ADDENDUM NO. 01

Oak Hill United School Corporation – Multi-School MEP Improvements
405 South Washington St, Swayzee, IN 46986
7760 Delphi Pike, Converse, IN 46919
600 Walnut St, Converse, IN 46919

Addendum One (AD.01) to the drawings and specifications prepared by Gibraltar Design for **Mechanical Improvements Across Three Schools** for Oak Hill United School Corporation Converse, Indiana.

ED102

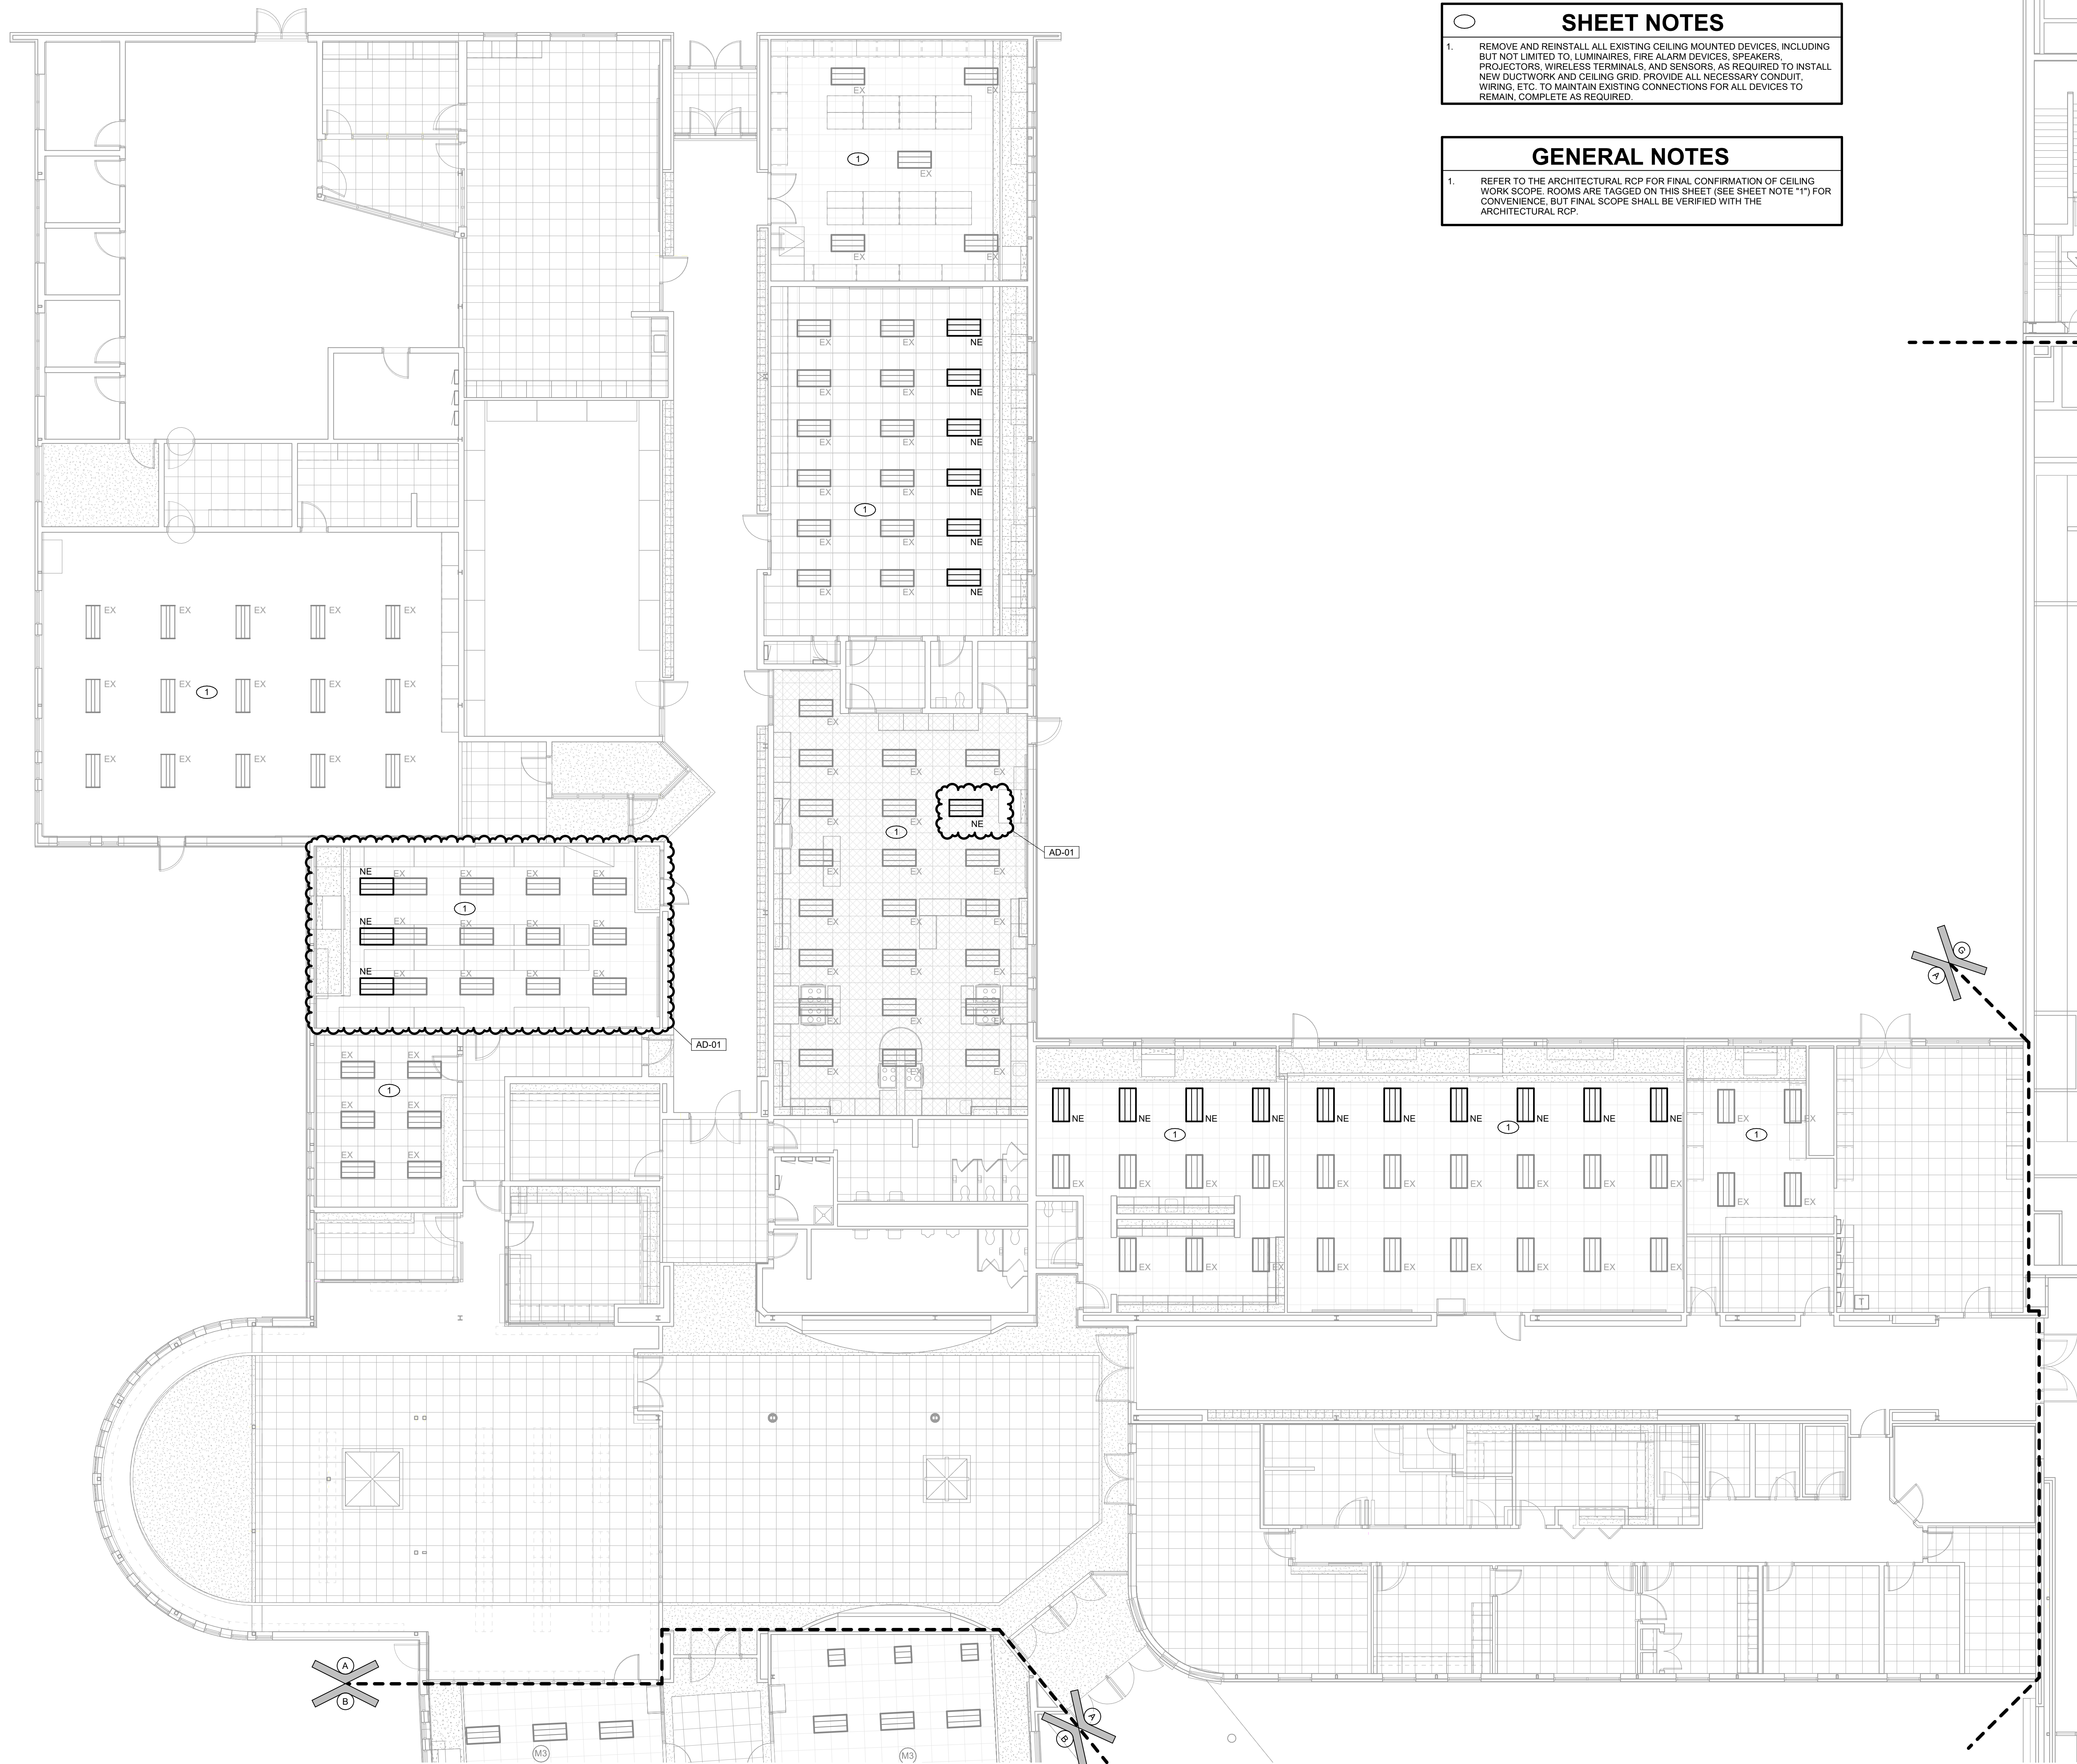
45. Sheet ED102

- A. Refer to revised, full-size drawing, included in this Addendum, for revisions.
 - 1. Added general note #2.
 - 2. Added sheet note #6.

EL101

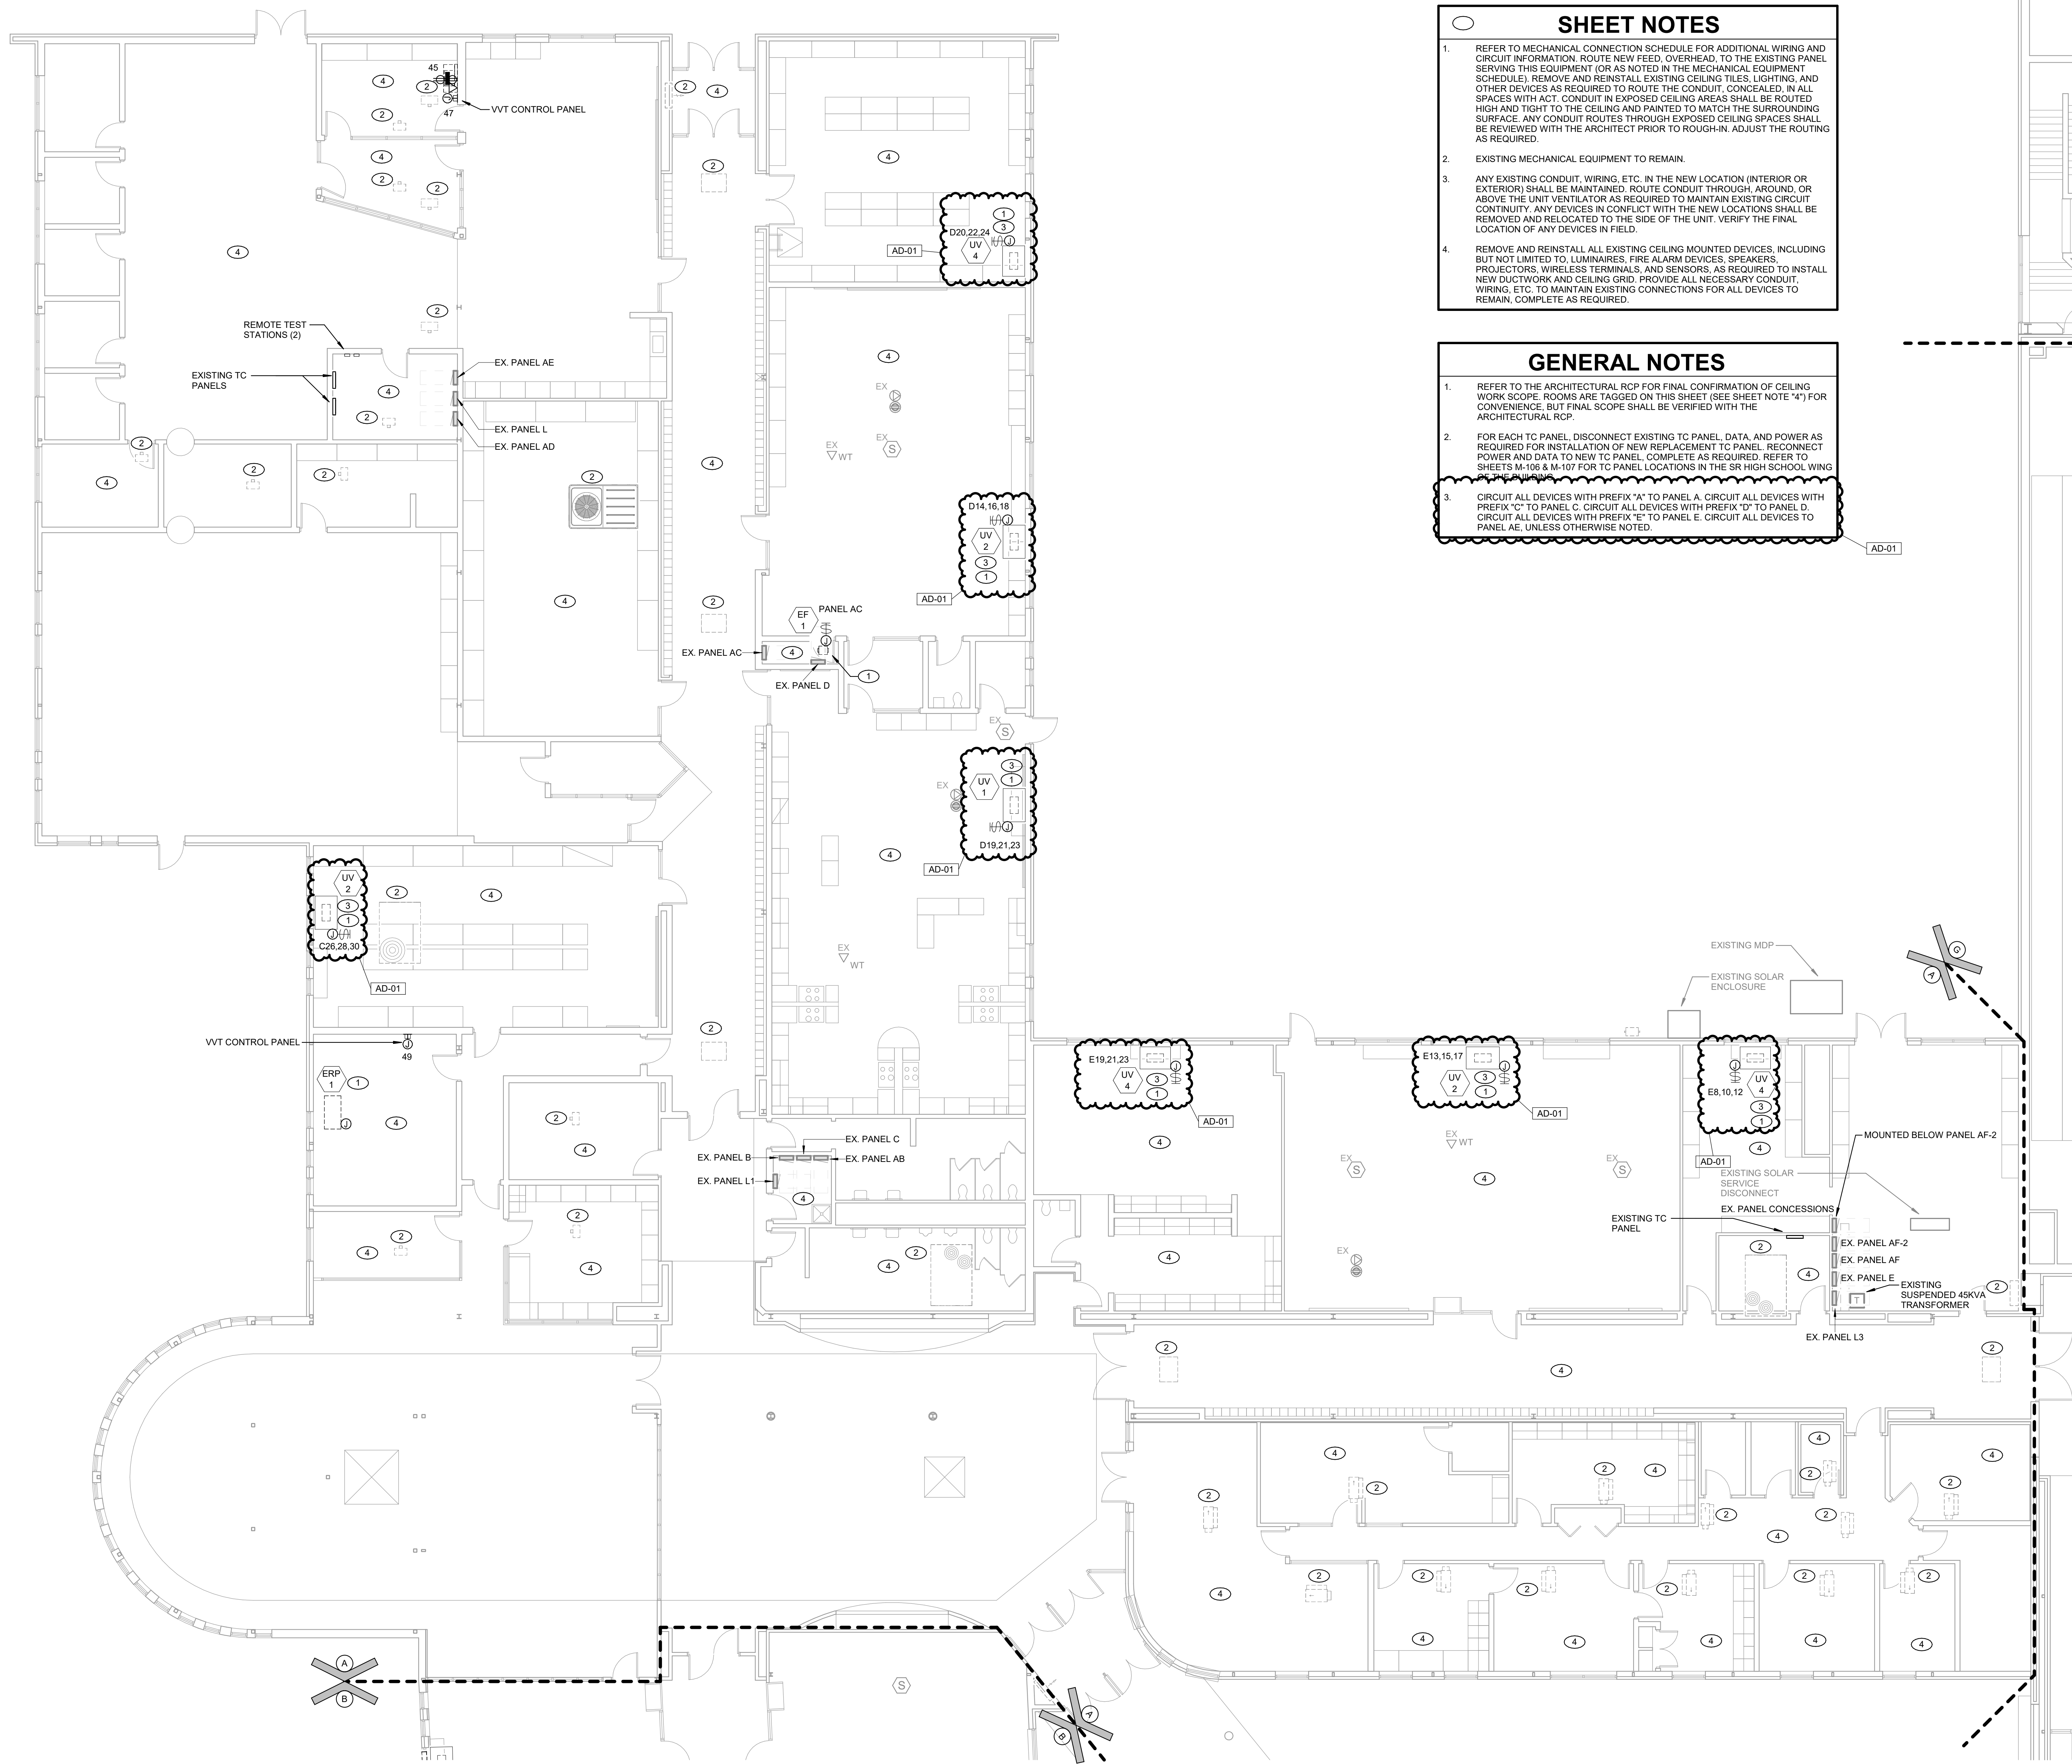
46. Sheet EL101

- A. Refer to revised, full-size drawing, included in this Addendum, for revisions.
 - 1. Revised lighting layout.
 - 2. Revised lighting phasing.

EP101

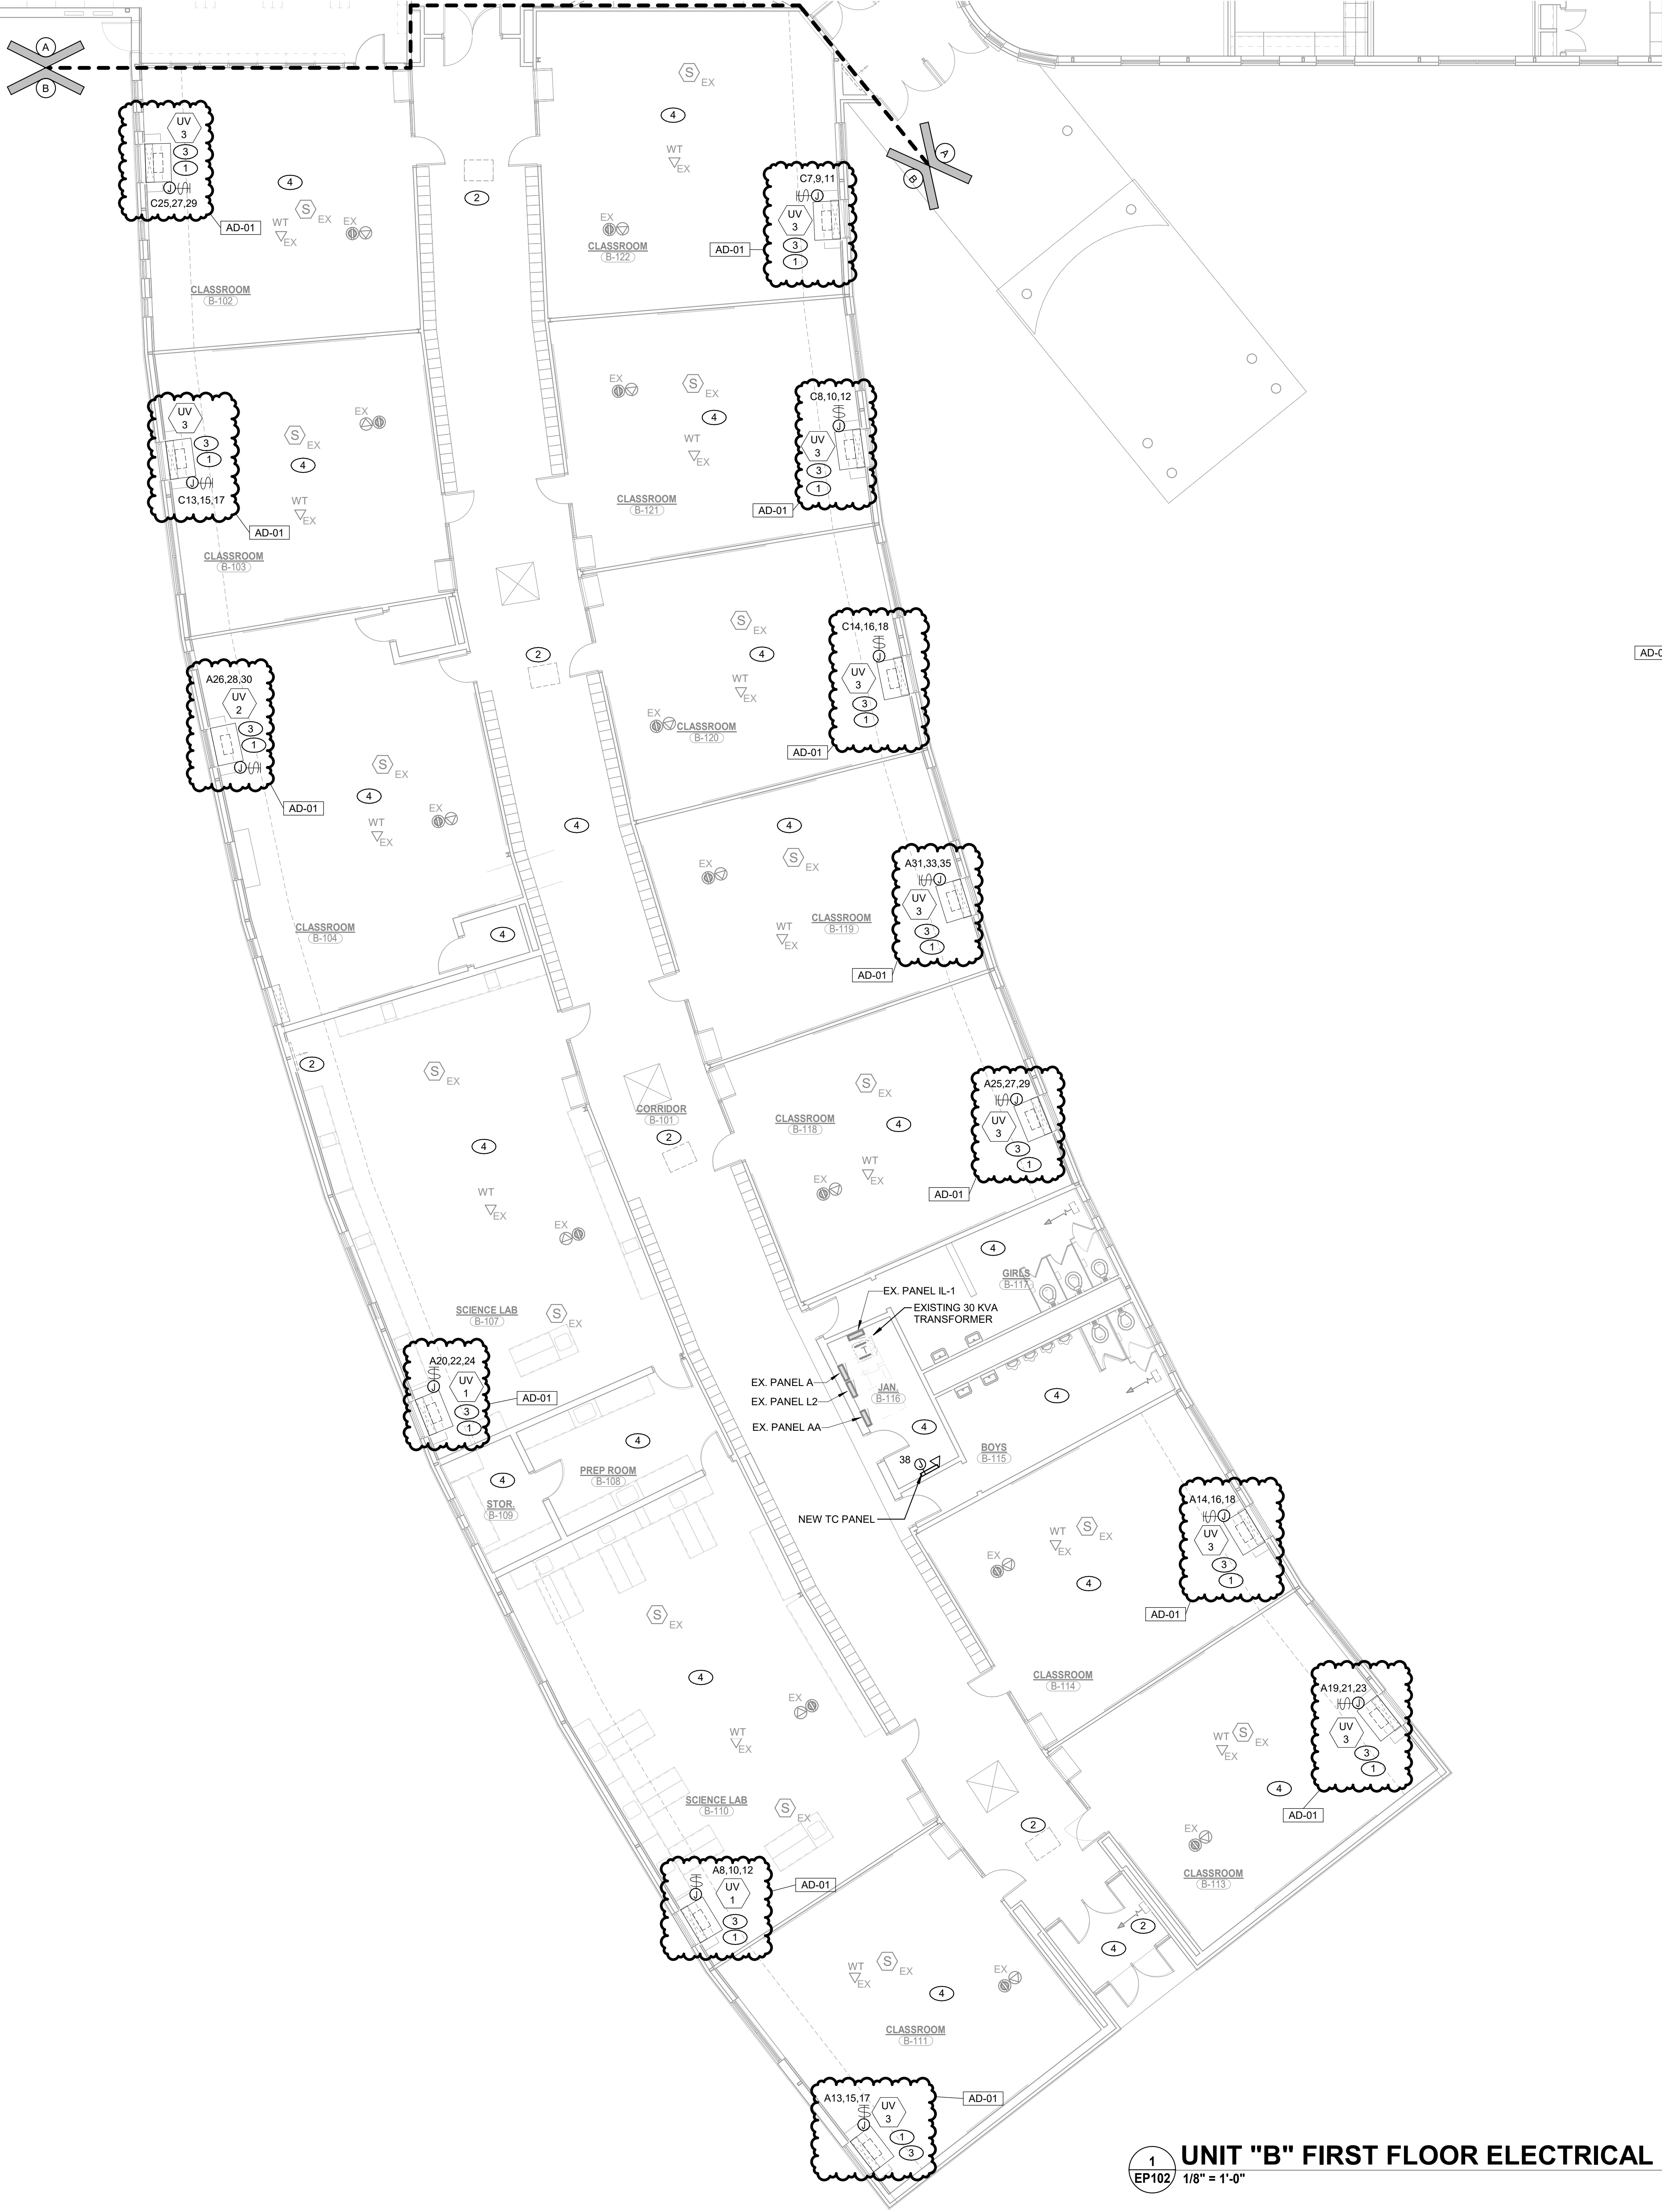
47. Sheet EP101

- A. Refer to revised, full-size drawing, included in this Addendum, for revisions.
 - 1. Added circuit tags to clarify what is already shown in the mechanical connection schedule.
 - 2. Revised general note #3.
